PIC10F220/222 Rev. A Silicon Errata

The PIC10F220/222 parts you have received conform functionally to the Device Data Sheet (DS41270B), except for the anomalies described below.

1. Module: Analog-to-Digital (A/D) Converter

FIGURE 1: TYPICAL DNL AT 2.0V (TESTING AT 7-BIT LEVEL)

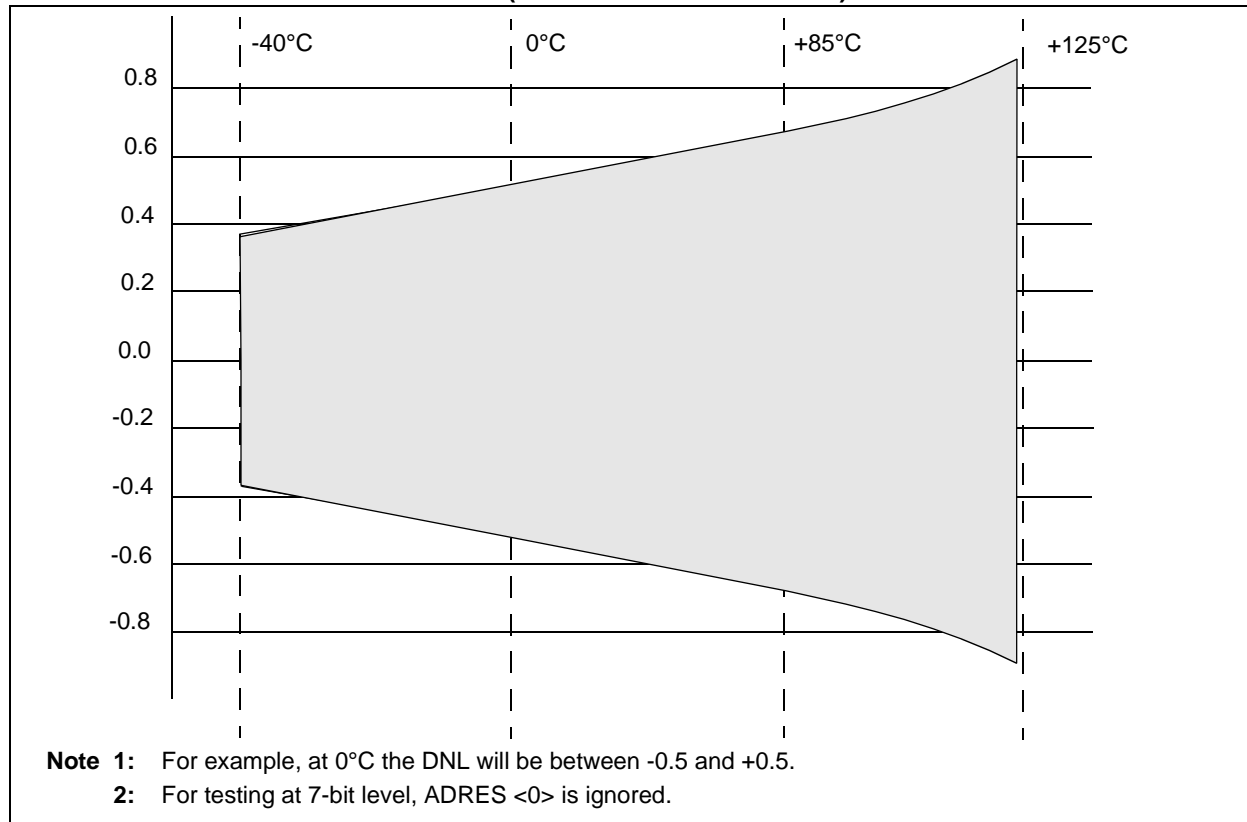
PIC10F220/222 silicon Rev. A1. The A/D Converter does not meet the design target. The specifications listed below in Table 10-6 supersede Table 10-6 in DS41270B.

Note 1: This will be addressed in future silicon revisions.

Work around:

None.
